ADDENDUM NO. 1

Job No. F70C616E
SAND ISLAND STATE RECREATION AREA
SEWER SYSTEM IMPROVEMENTS
PHASE 2: PUMP STATION 3 RELOCATION & FM 3 REPLACEMENT
Honolulu, Oahu, Hawaii

02/22/21

| APPROVED: | DRAWING NO. C012 |

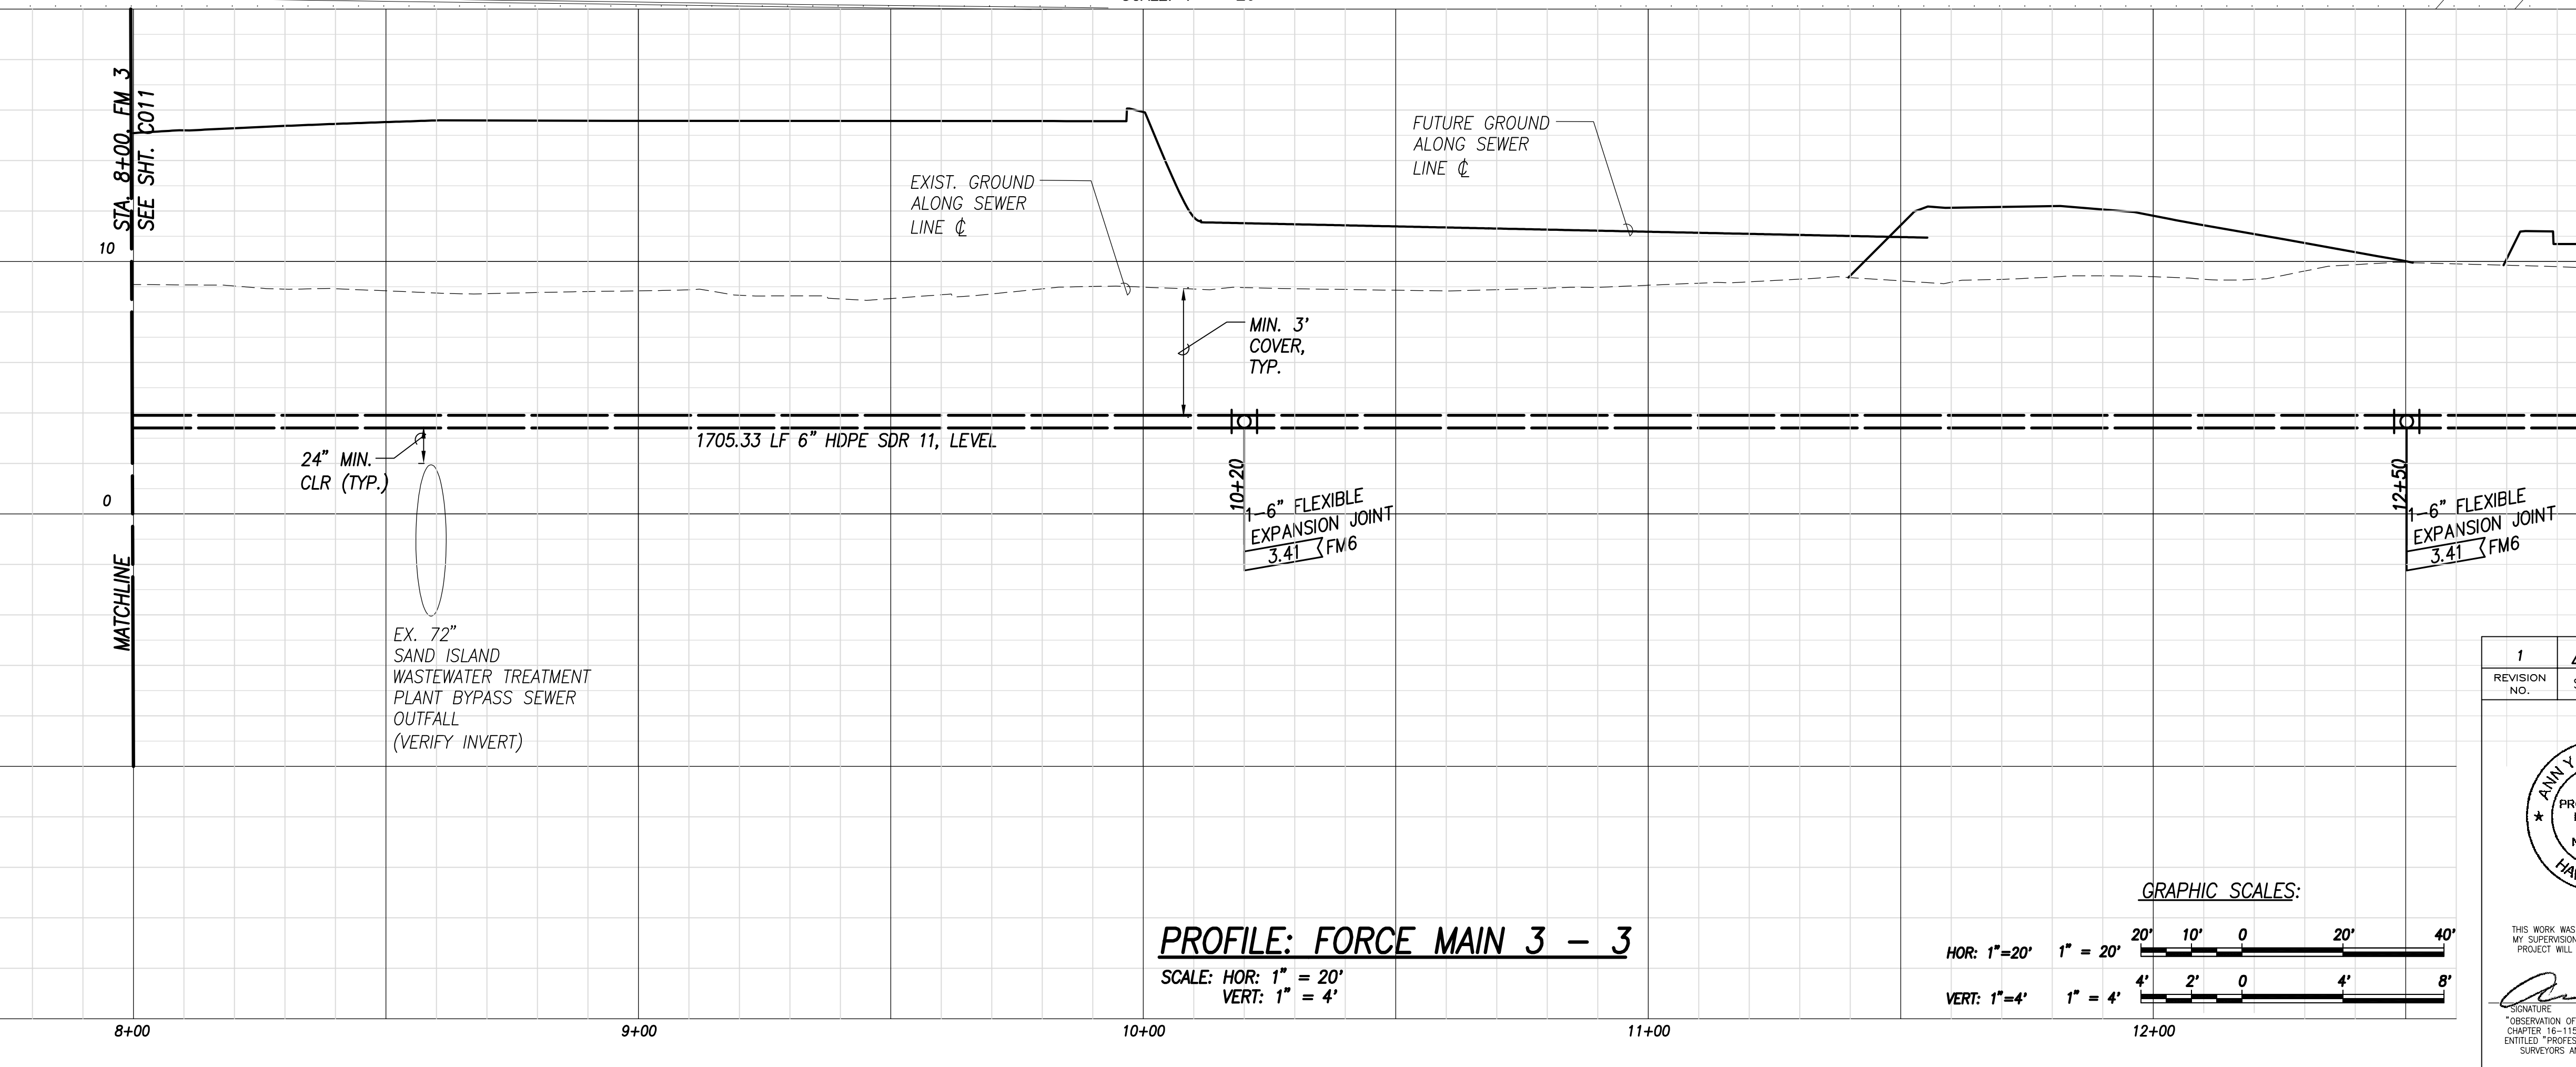
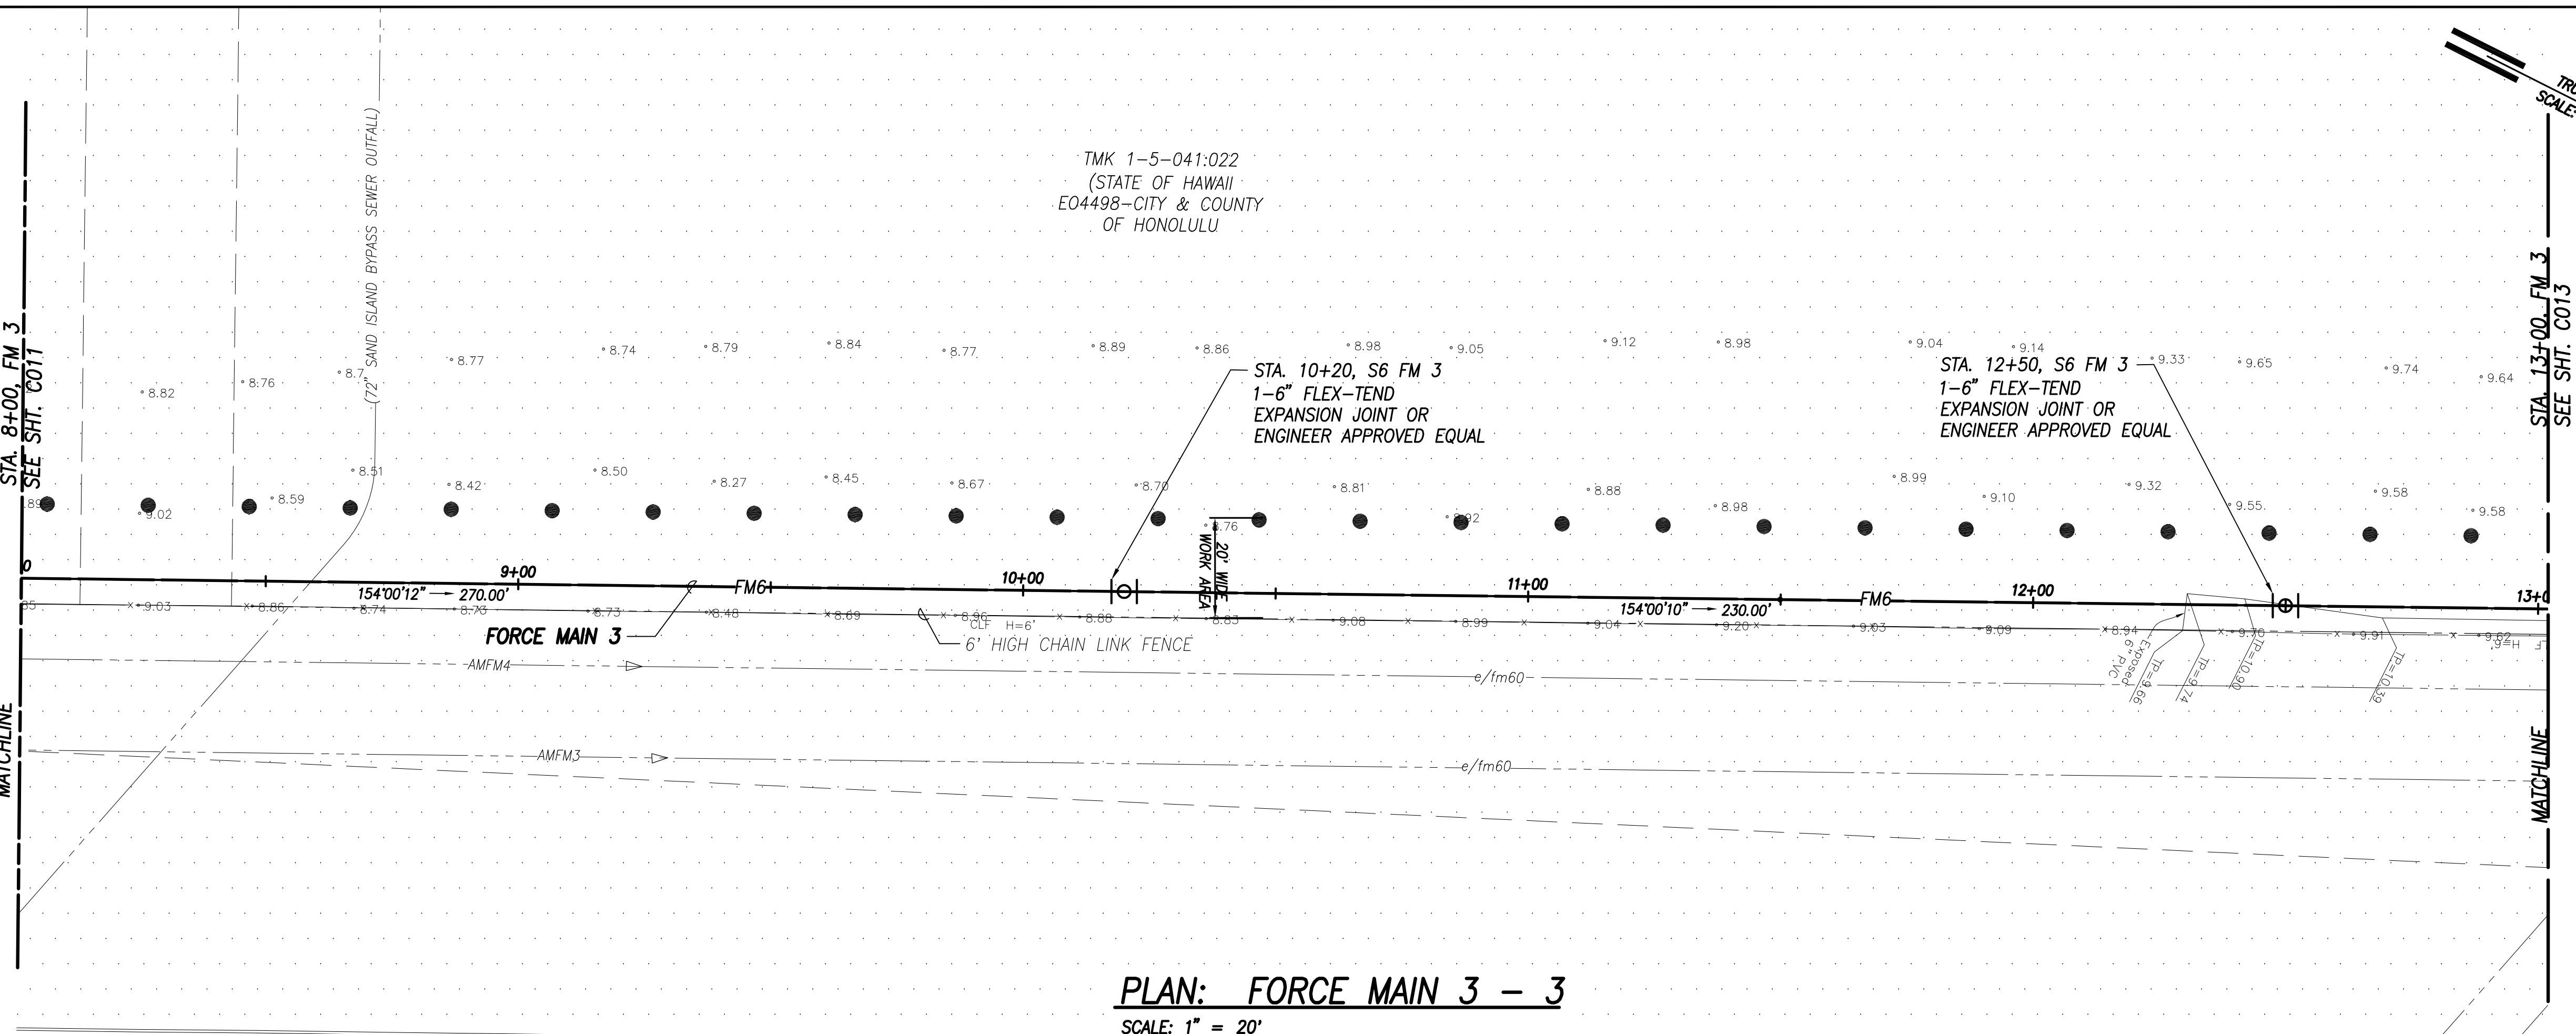
- j. Added Note #9, “Contractor must complete Phase 1 work by June 7, 2021.”
7. Sheet C012, “Force Main 3 Plan and Profile – 3.”
- a. Removed Note #1, “Contractor to provide continuous sewer service.”

- b. Removed Note #2, “Contractor shall restore all disturbed areas back to original condition or better.”
 - c. Added Note #5, “EO area for Phase 1 to be shared by various contractors, Contractor shall coordinate with concurrent and future projects. See sheet C005A.

- d. Added Note #6, “Contractor does not need to restore ground cover after backfilling trench for Construction Phase 1.”
 - e. Added Note #7 “Contractor must complete Phase 1 work by June 7, 2021.”

PLAN: FORCE MAIN 3 - 4
SCALE: 1" = 20'

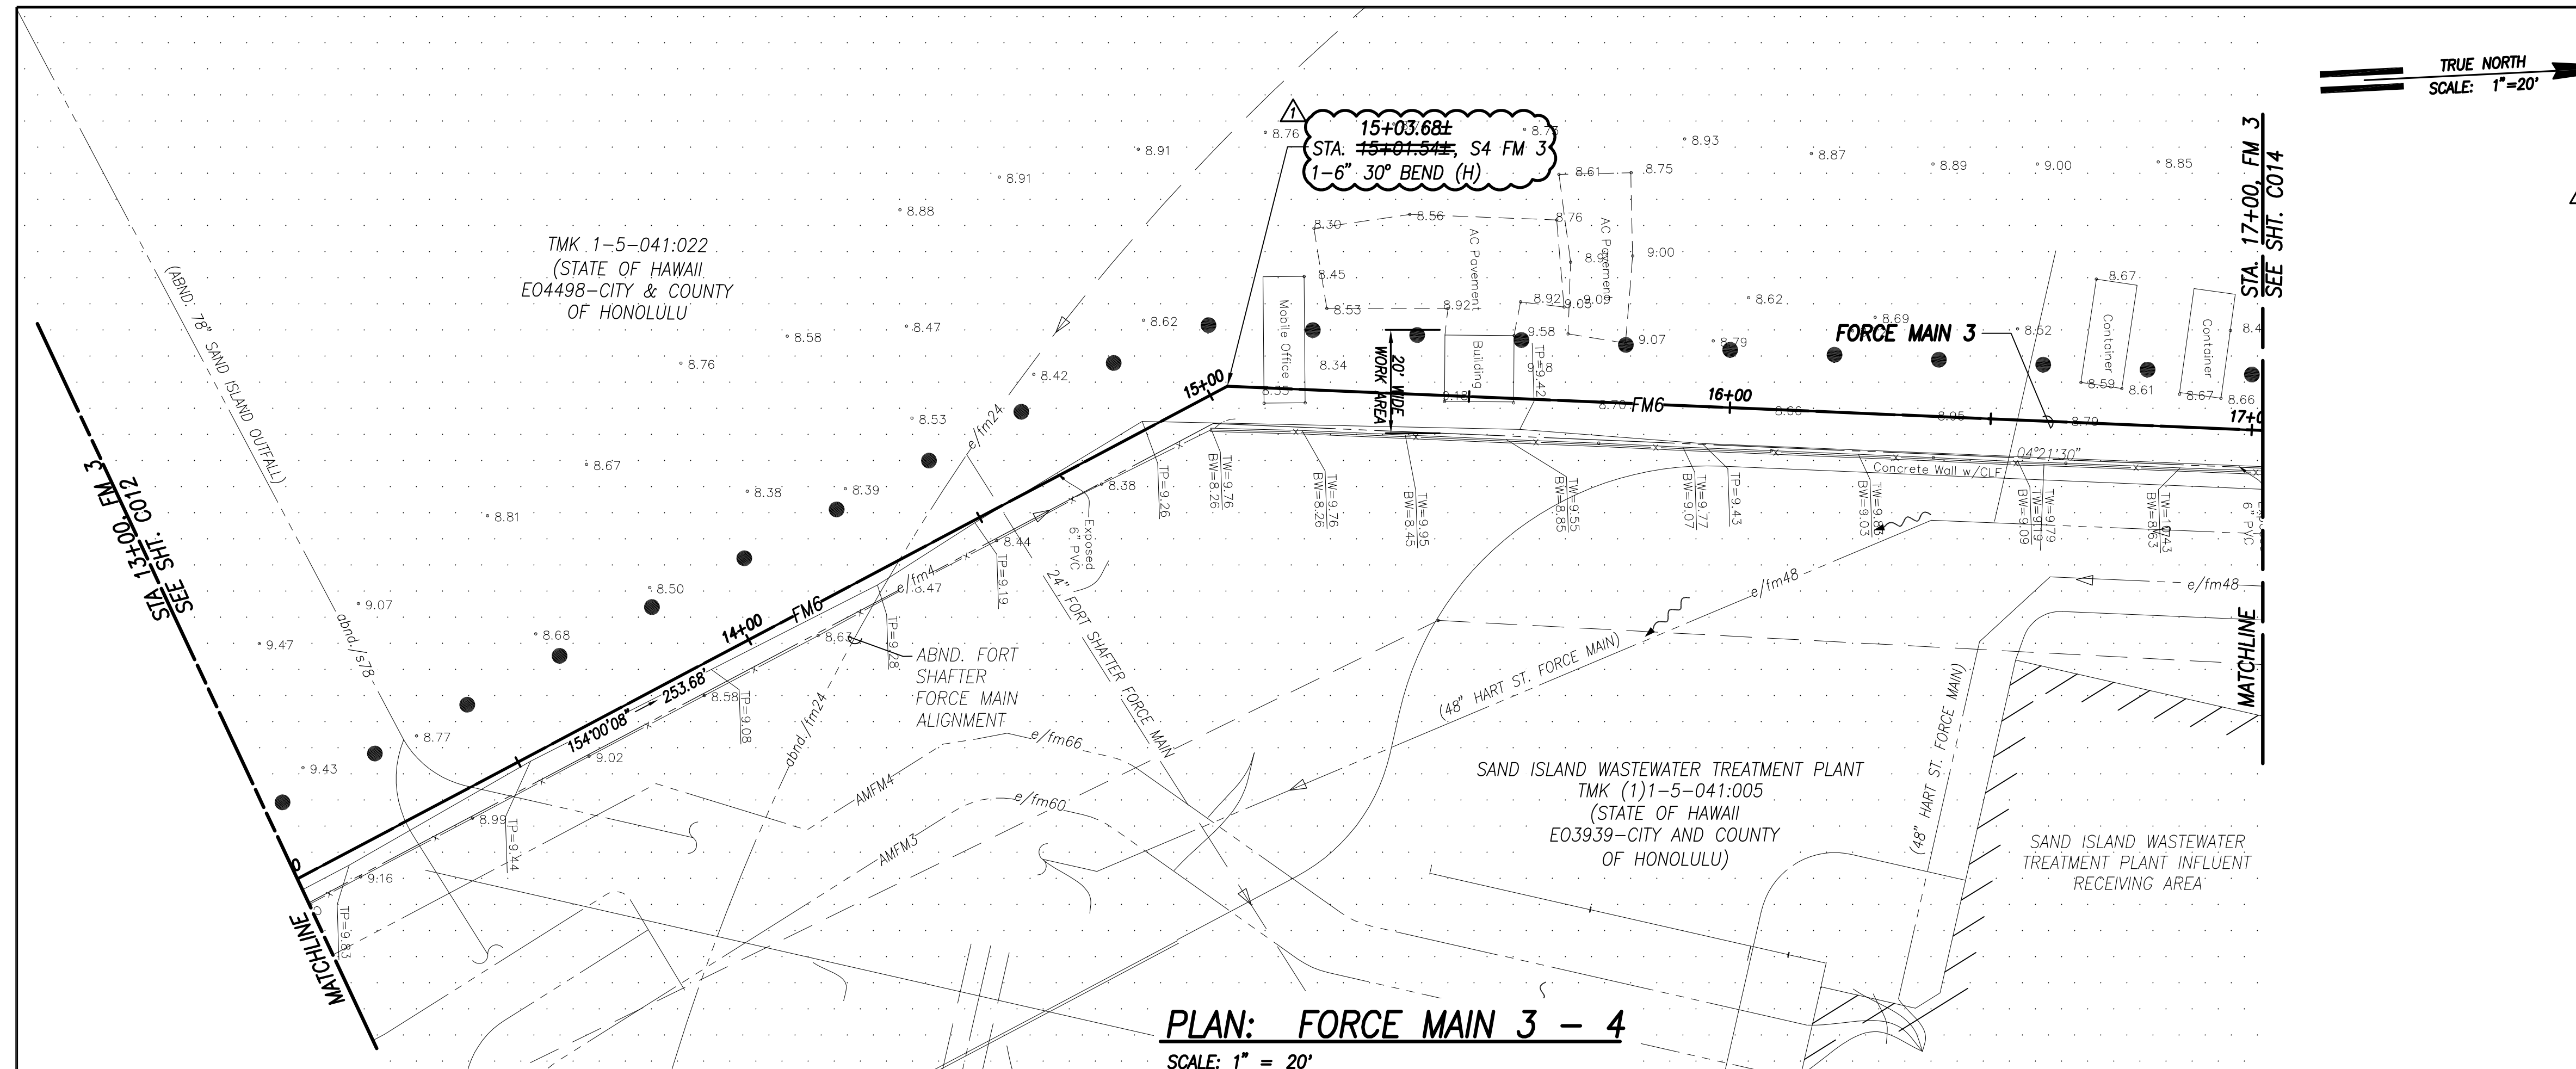
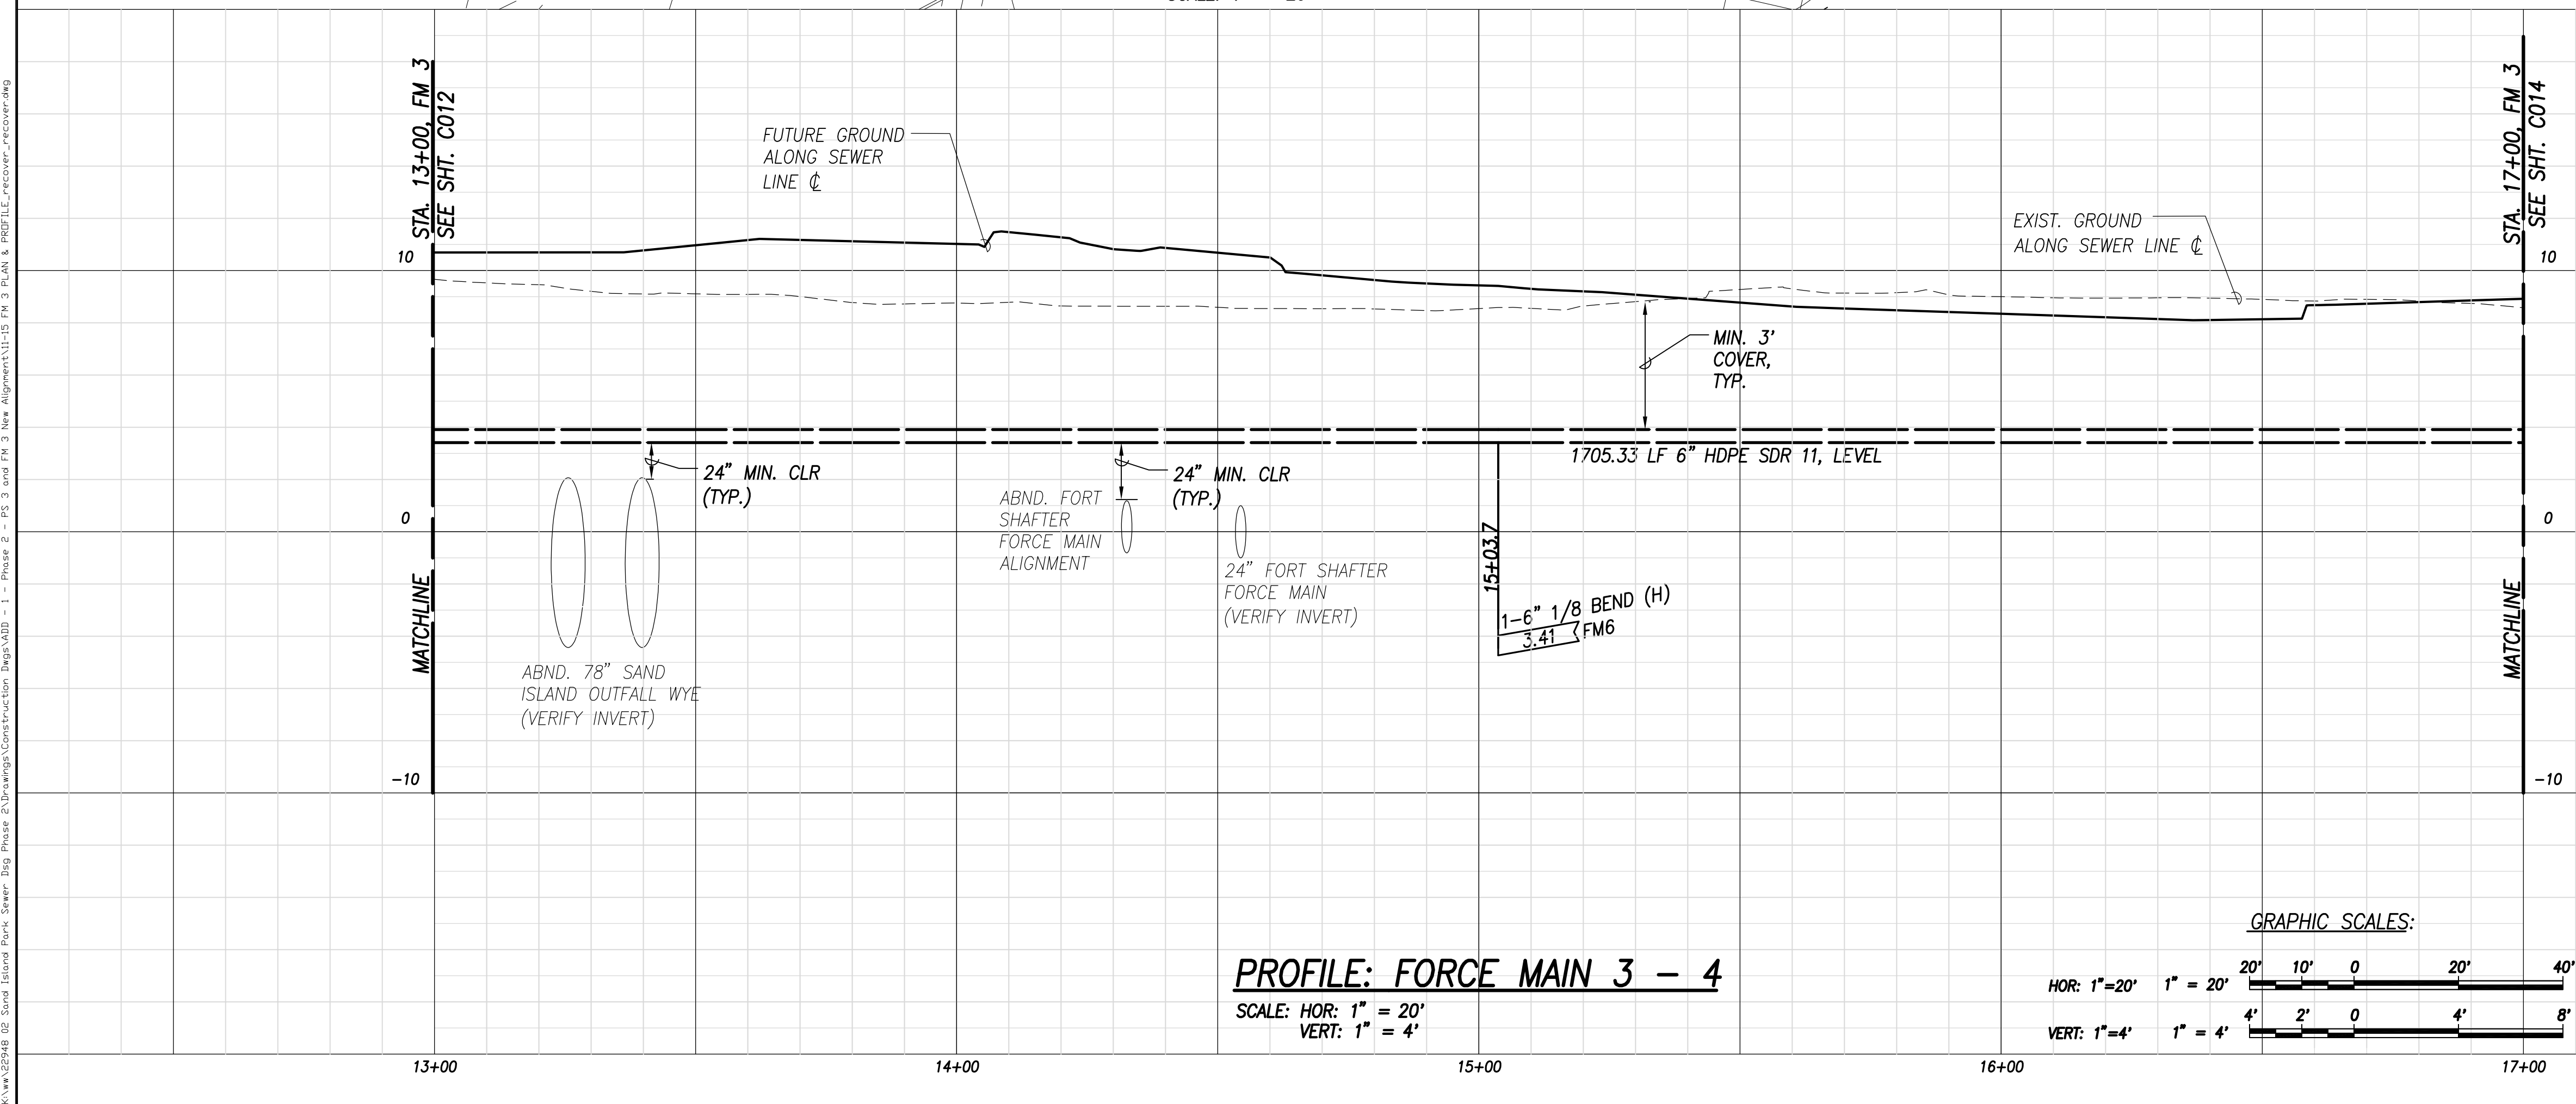
8. Sheet C013, “Force Main 3 Plan and Profile – 4.”
- a. Revised stationing for horizontal bend to “15+03.68”
 - b. Removed Note #1, “Contractor to provide continuous sewer service.”

- c. Removed Note #2, “Contractor shall restore all disturbed areas back to original condition or better.”
 - d. Removed Note #4, “Contractor to verify if any containers buildings, etc. within new FM alignment needs to be relocated and /or demolished. All cost incidental to project.”

- e. Added Note #5, “EO area for Phase 1 to be shared by various contractors, Contractor shall coordinate with concurrent and future projects. See sheet C005A.

- f. Added Note #6, “Contractor does not need to restore ground cover after backfilling trench for Construction Phase 1.”
 - g. Added Note #7 “Contractor must complete Phase 1 work by June 7, 2021.”
